APICAL INDUSTRIES, INC.
dba DART AEROSPACE

ENGINEERING CHANGE NOTICE NO.

DWG NO. 647.7700

DWG TITLE: STRUT ASSY

05397

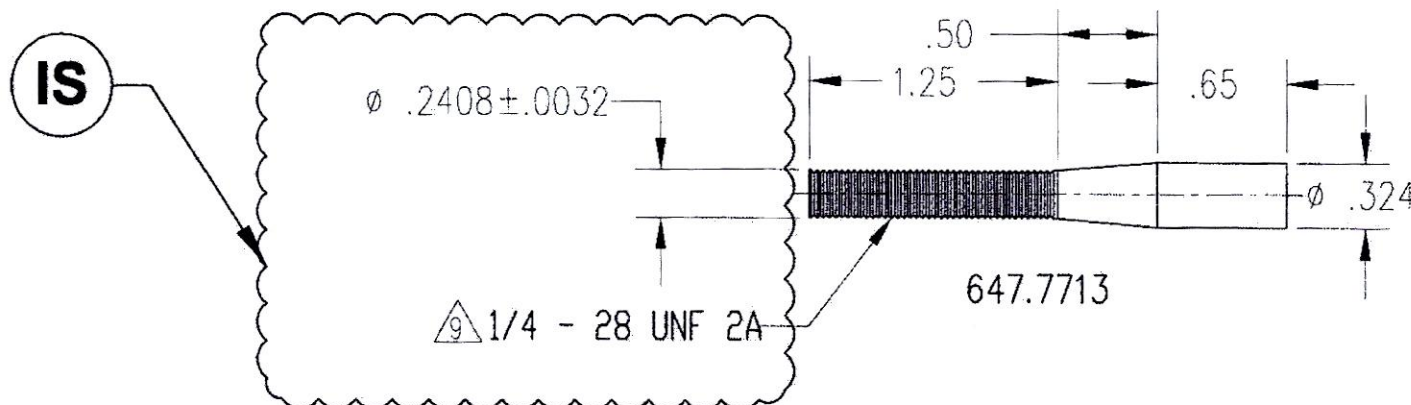
REASON: REVISED DIMENSION

SHEET 2, ZONE D4 IS:

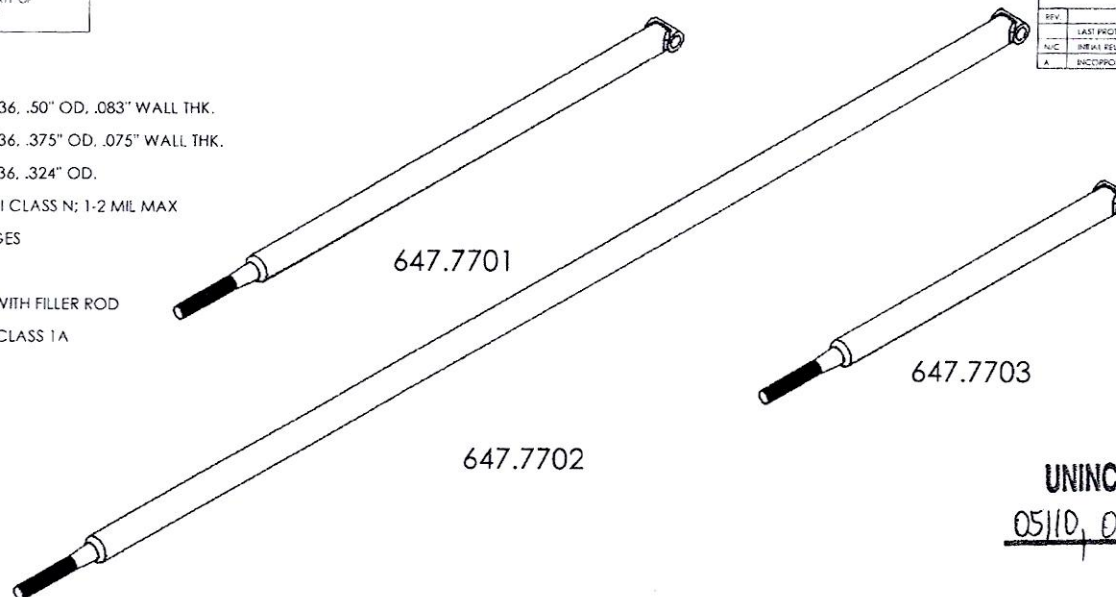
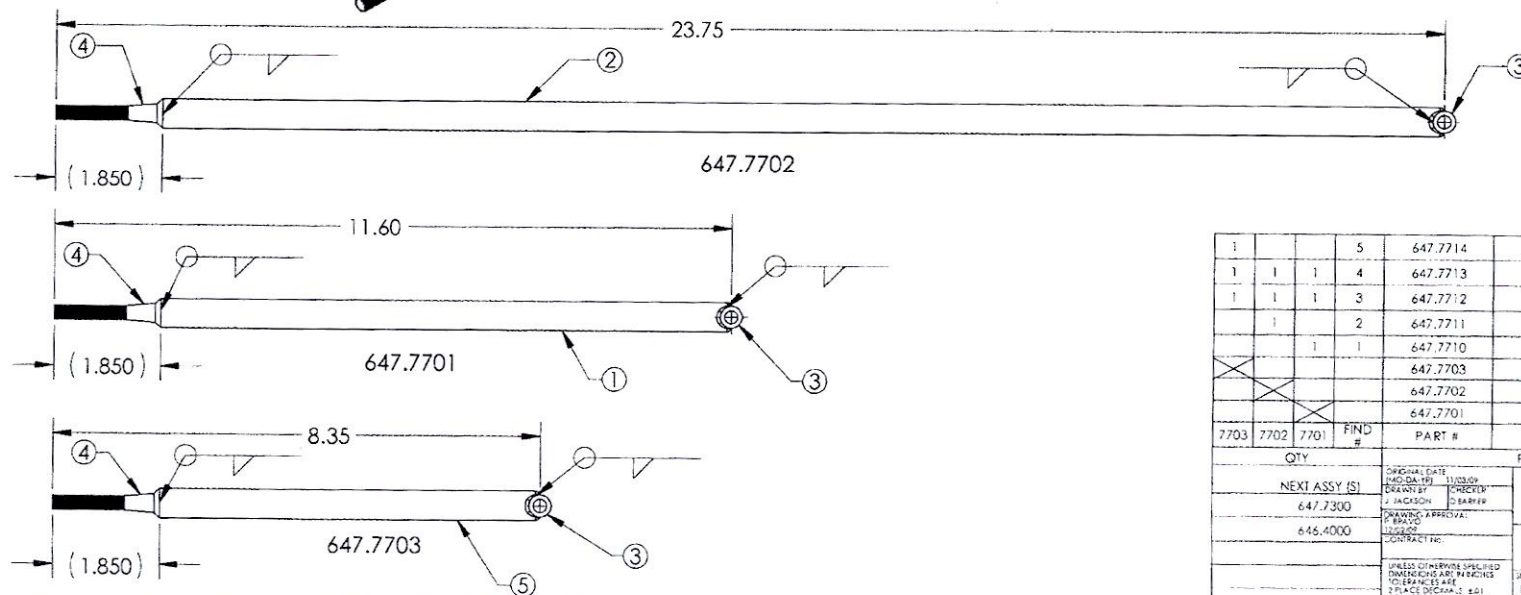
REASON: REVISED FINISH CALLOUT AS PER ECR 15-209

SHEET 1, NOTES IS:

- 1 MATERIAL: 4130 STEEL PER AMS-T-6736, .50" OD, .083" WALL THK.
- 2 MATERIAL: 4130 STEEL PER AMS-T-6736, .375" OD, .075" WALL THK.
- 3 MATERIAL: 4130 STEEL PER AMS-T-6736, .324" OD.
- 4 FINISH: PRIME IAW MIL-P-2337J TYPE I CLASS N; 1-2 MIL MAX
5. DEBURR AND BREAK ALL SHARP EDGES
6. IDENTIFY IAW MPP-120.
- 7 WELD IAW MIL-STD-2219, TIG WELD WITH FILLER ROD
- 8 FINISH: CAD PLATE IAW QQ-P-416F CLASS I TYPE II
- 9 MASK THREAD PRIOR TO FINISH
